UNIT WELL 31 WATER TREATMENT PLANT  
 MADISON WATER UTILITY  
 MADISON, WISCONSIN

MARK: REV A=1  
 DATE: 2/9/17  
 ADDENDUM 1  
 REV. FENCES

SHEET TITLE  
 UNIT WELL 31  
 SITE PLAN

SHEET  
**C1**

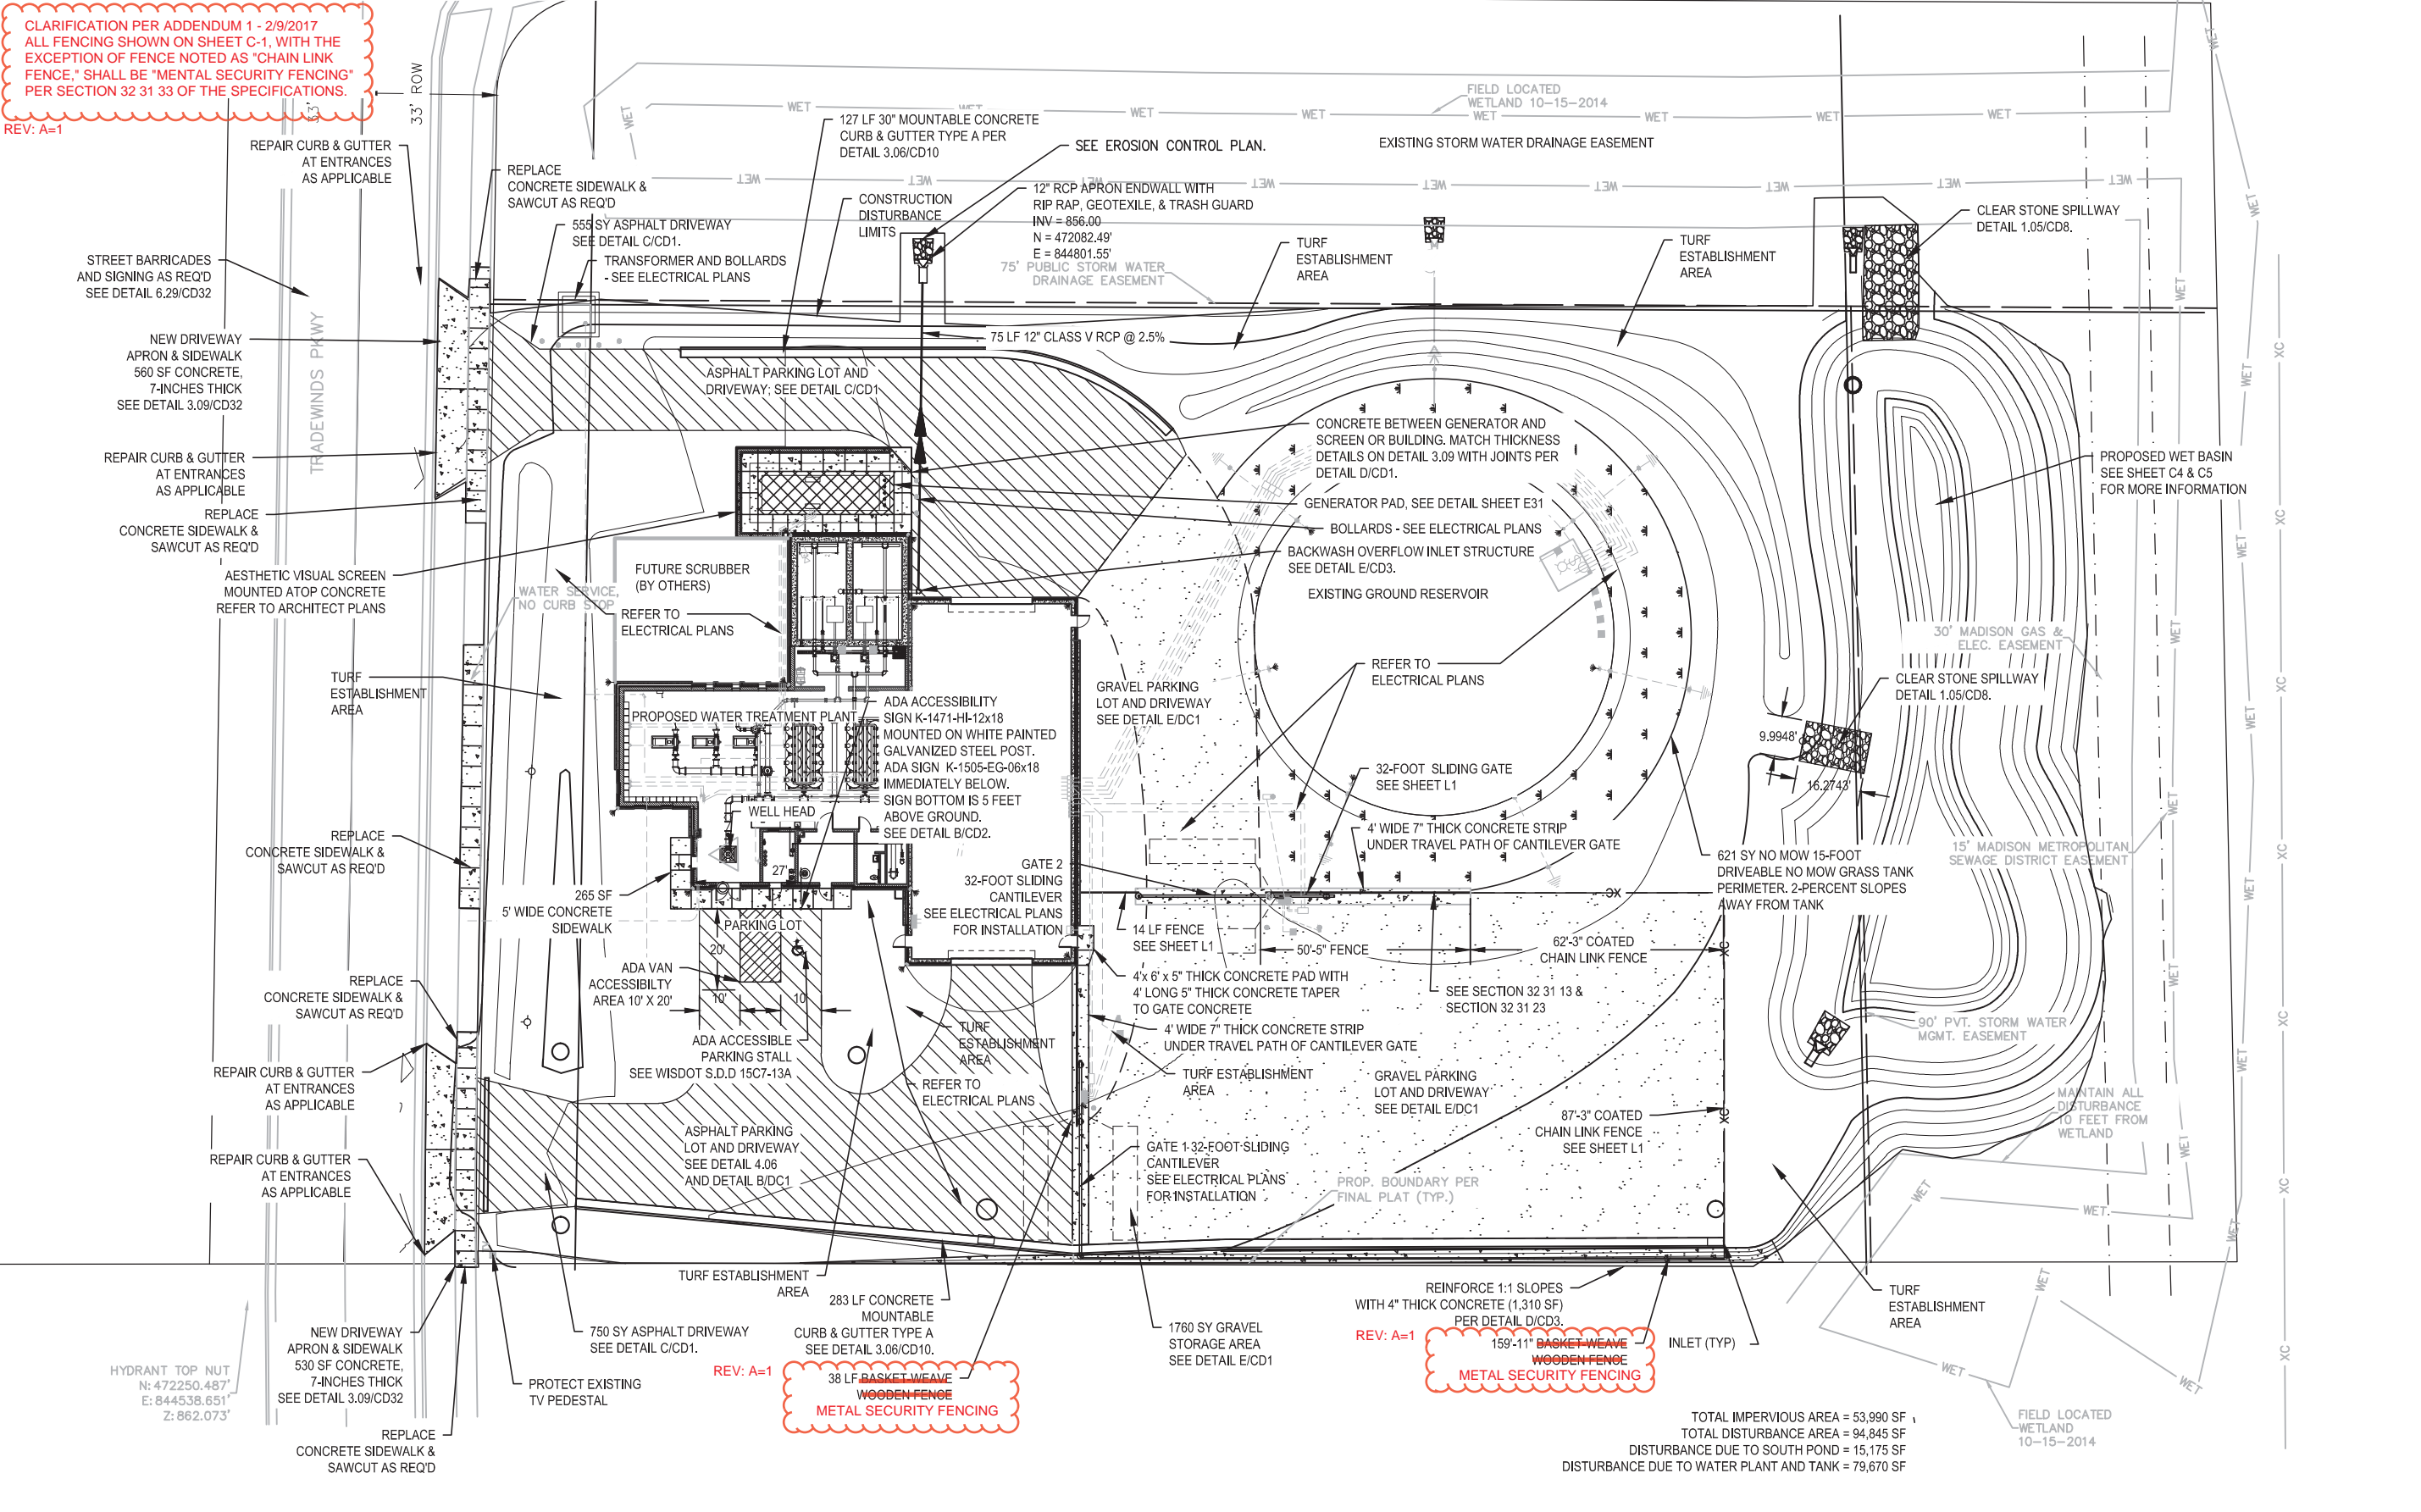
**CLARIFICATION PER ADDENDUM 1 - 2/9/2017**  
**ALL FENCING SHOWN ON SHEET C-1, WITH THE EXCEPTION OF FENCE NOTED AS "CHAIN LINK FENCE," SHALL BE "METAL SECURITY FENCING" PER SECTION 32 31 33 OF THE SPECIFICATIONS.**

REV: A=1  
**38 LF BASKET WEAVE WOODEN FENCE METAL SECURITY FENCING**

C2

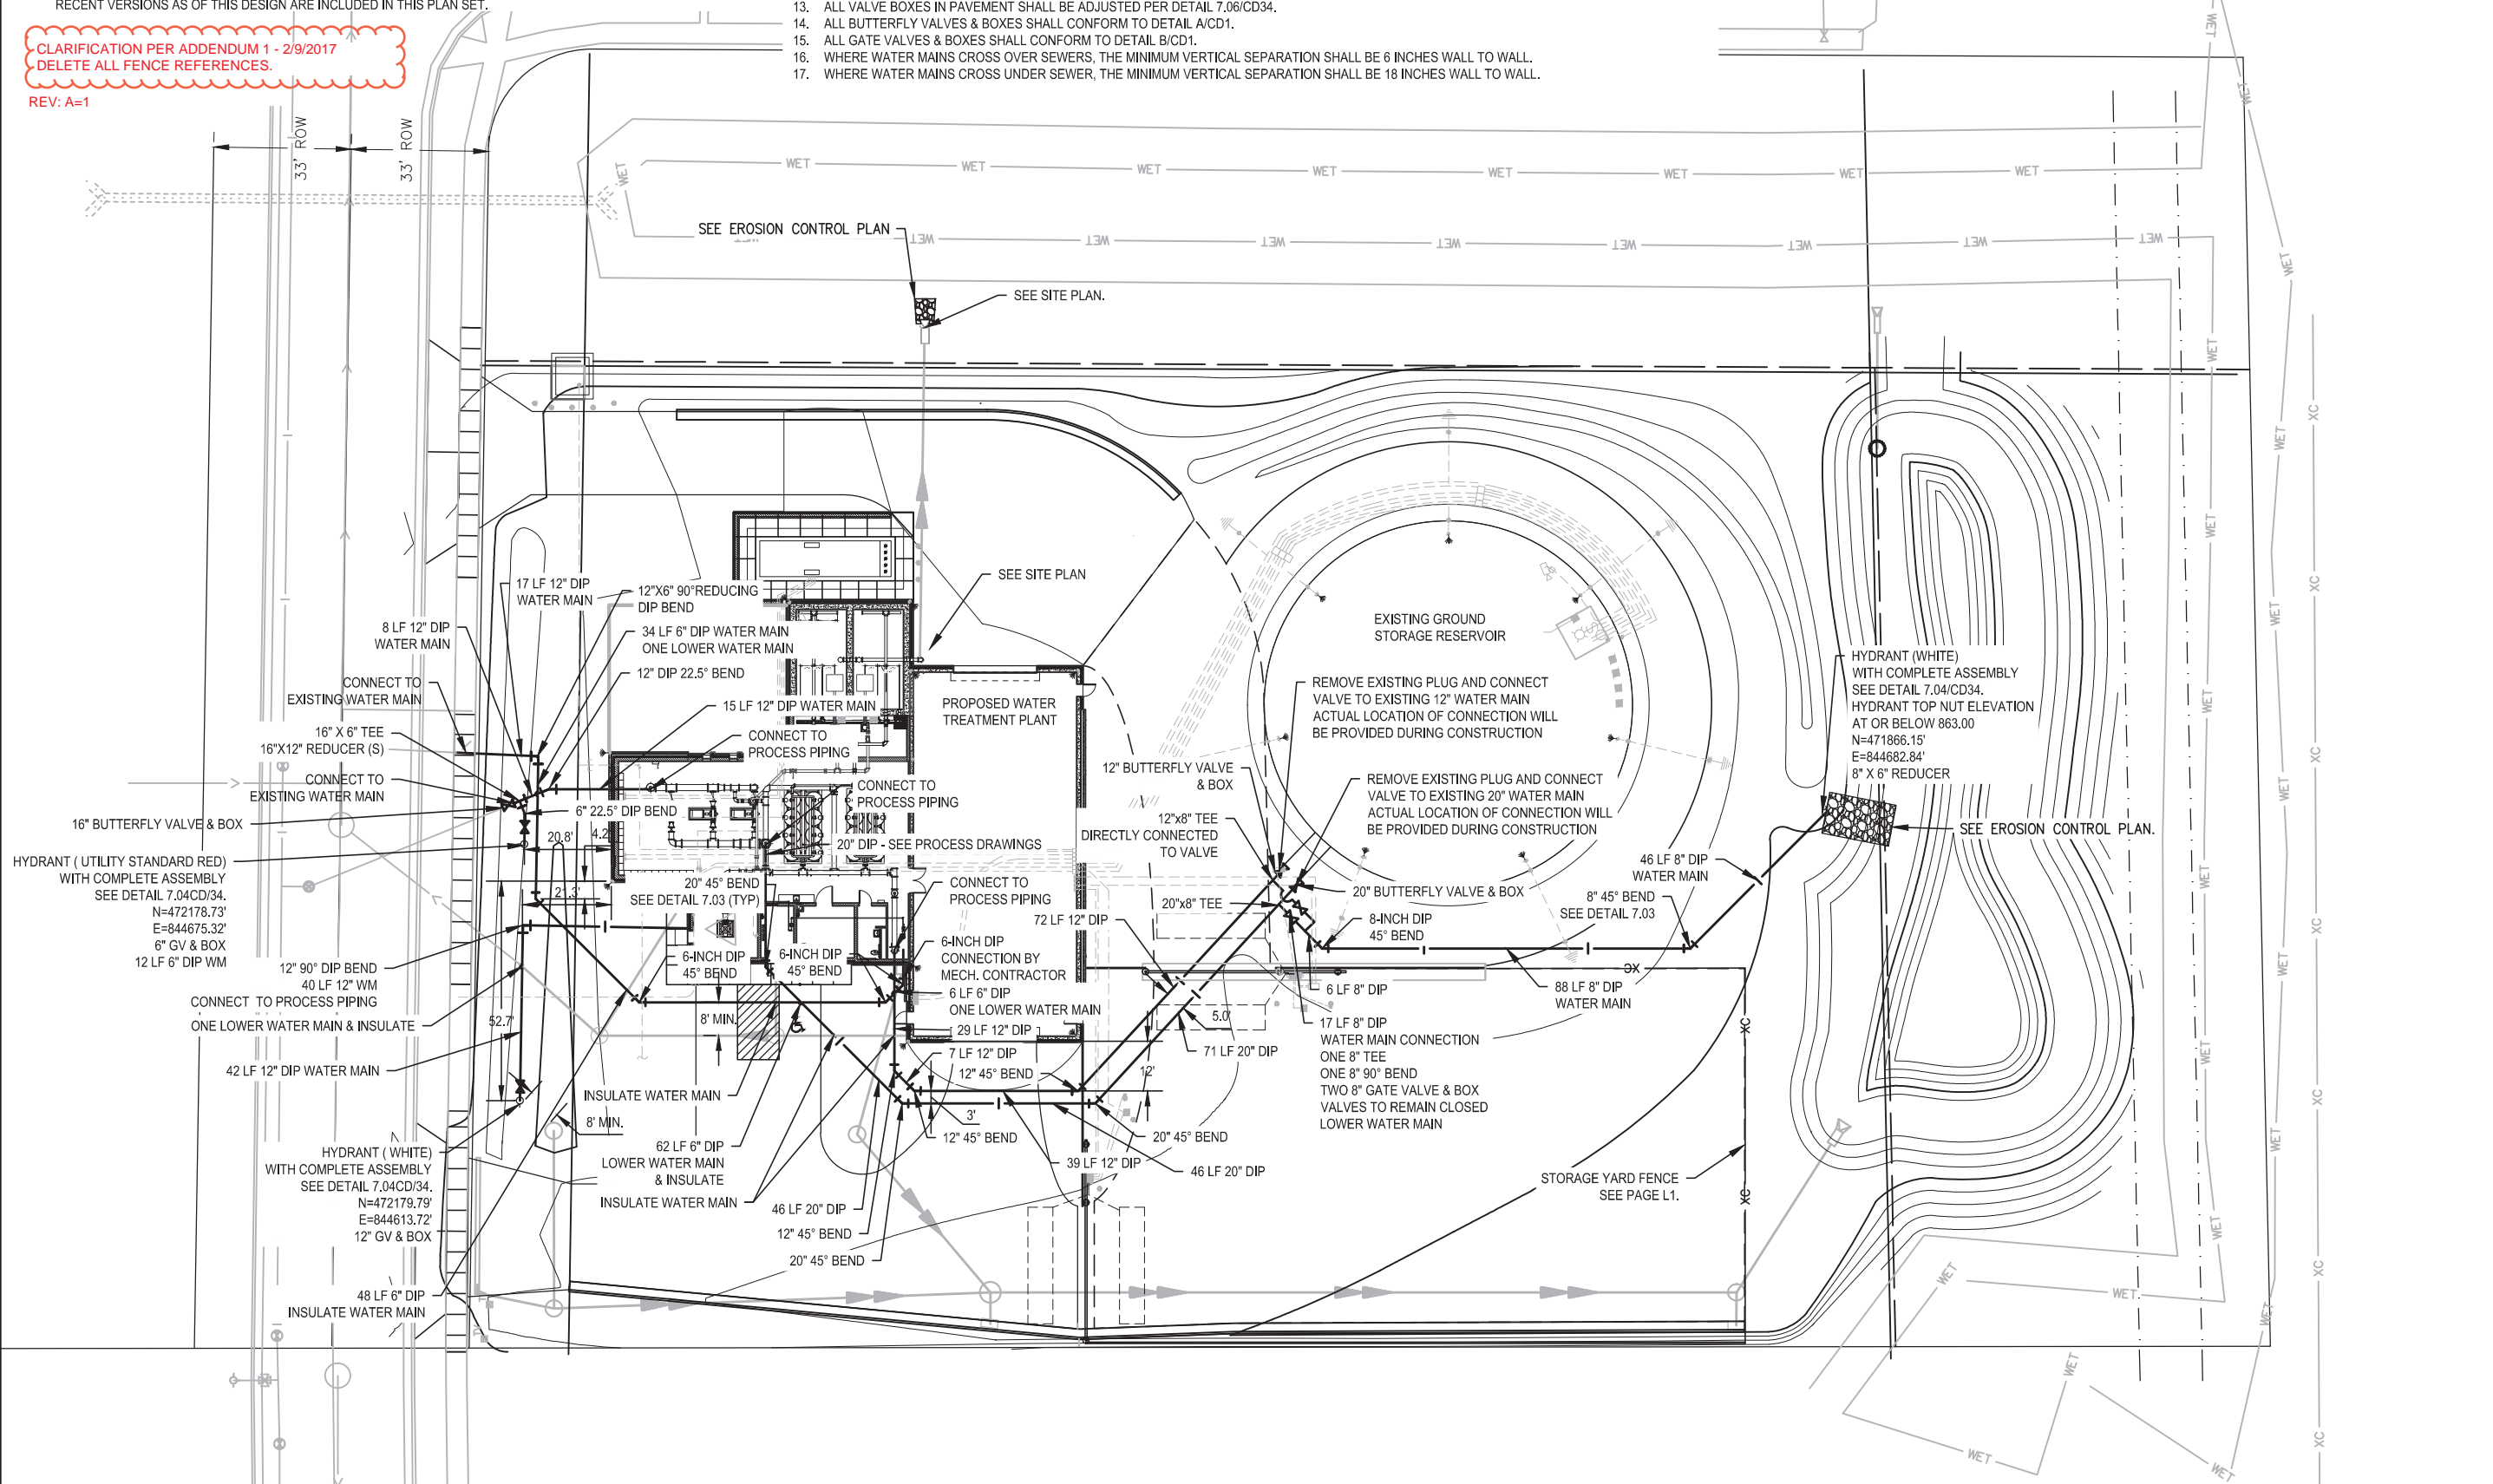
CLARIFICATION PER ADDENDUM 1 - 2/9/2017  
DELETE ALL FENCE REFERENCES.
